# UNITED STATES PATENT AND TRADEMARK OFFICE

APPLICATION NO.	FILING DATE	FIRST NAMED INVENTOR	ATTORNEY DOCKET NO.	CONFIRMATION NO.
09/990,013	11/21/2001	James E. Johanson	8945-25 (149194)	2419
7590	09/09/2004		EXAMINER	
Thomas J. Durling Drinker Biddle & Reath LLP One Logan Square 18th and Cherry Streets Philadelphia, PA 19103-6996			LE, TAN	
			ART UNIT	PAPER NUMBER
			3632	
			DATE MAILED: 09/09/2004

**Office Action Summary**

**DETAILED ACTION**

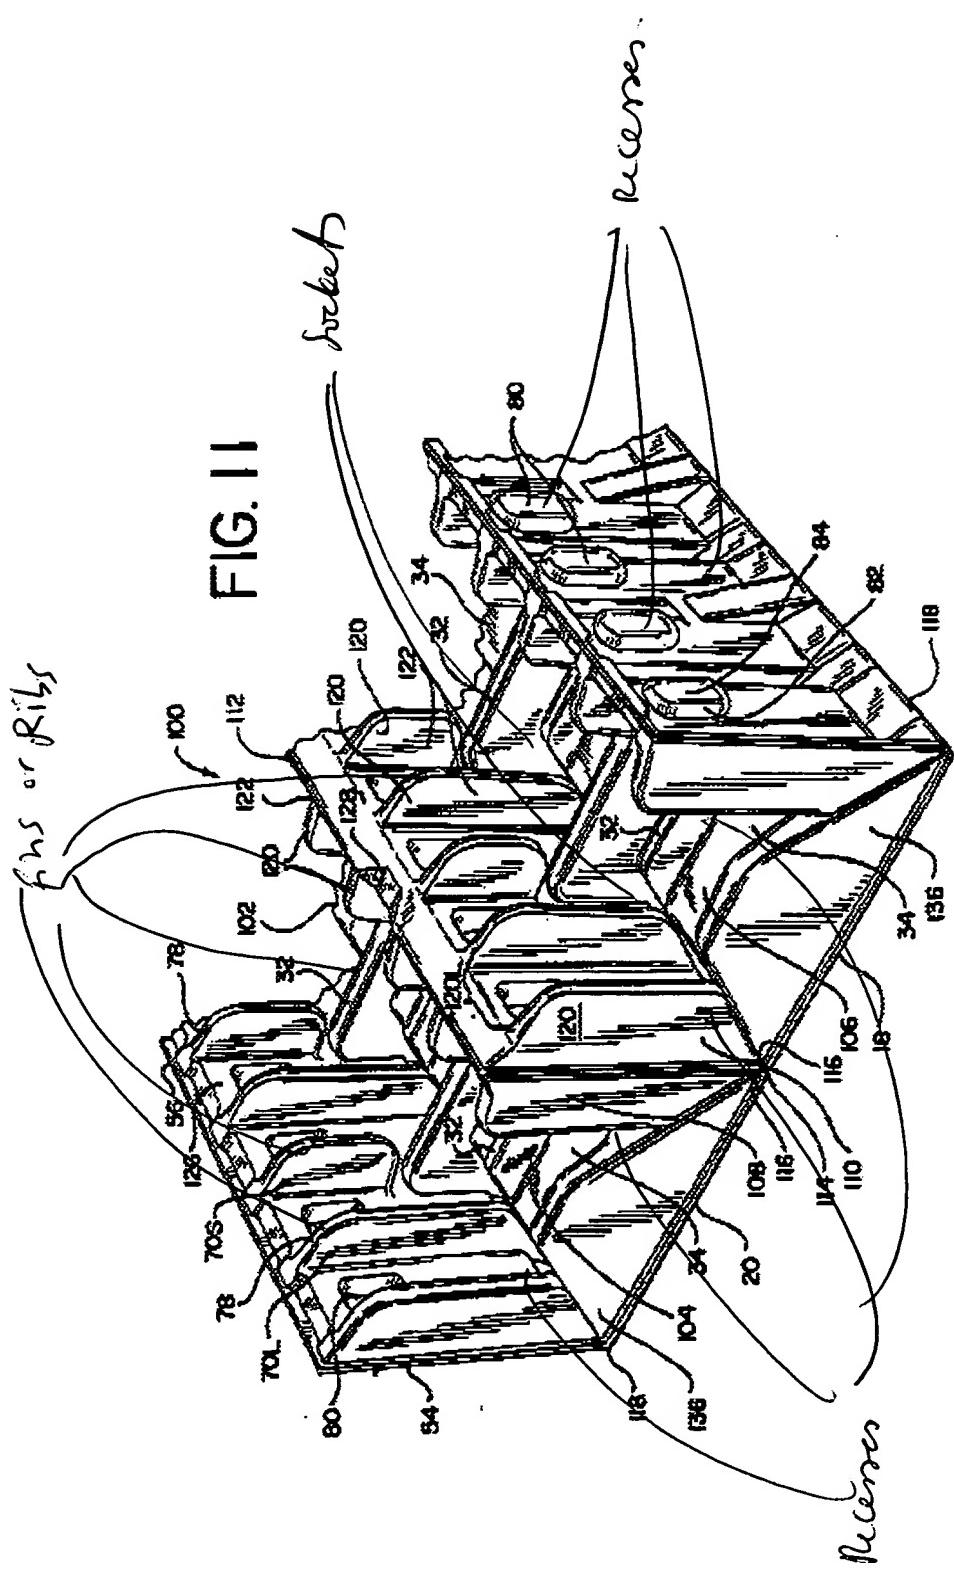
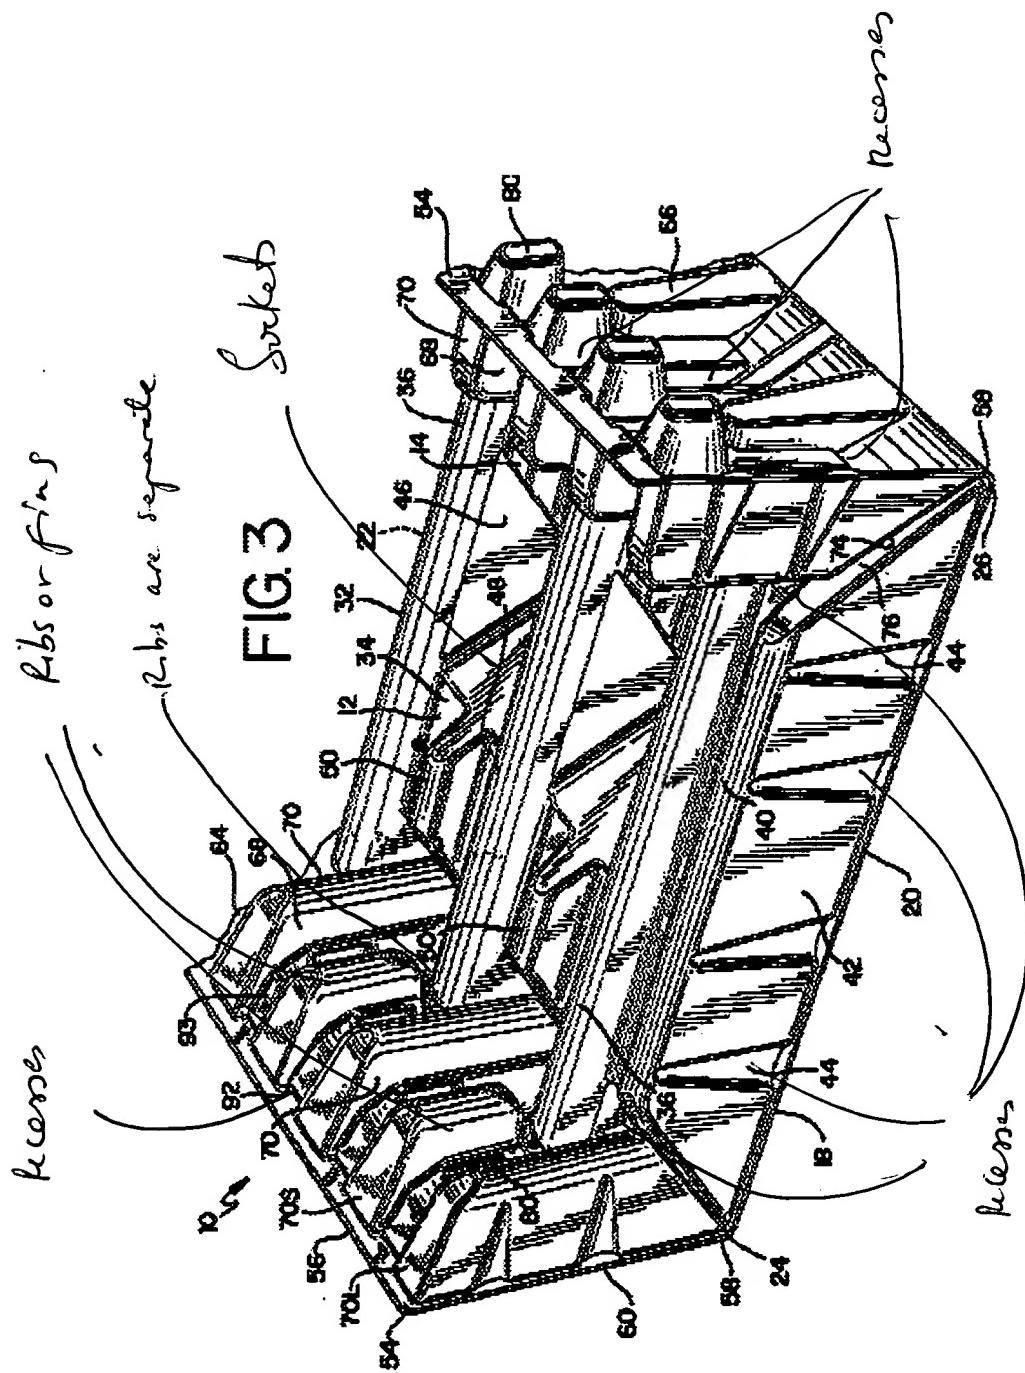
Claims 8-9, 10, 1-2, 7, 11-12, 13-14, 15-16, 18-19 and 20-24 are rejected under 35 U.S.C. 102(b) as being anticipated by US Patent No. 6,010,007 to Moren et al.

Moren et al. discloses a base for packaging an article comprising a frame (10) (Figs 3 or 11 for example) having four sides and an outer peripheral edge of each of the sides of the frame being recessed (see marked-up copy below) relative to the inner portion of the base along the corresponding side, the recess being created a gap between the base and the adjacent portions; the base having at least one socket; a plurality of flexible ribs or fins (70, 70S, 70L) extending along the internal sidewall of the socket and projecting inwardly into the well of the socket; wherein the ribs are beveled adjacent the upper edge of the socket and the bottom edges of the ribs are separated from the bottom wall of the socket.
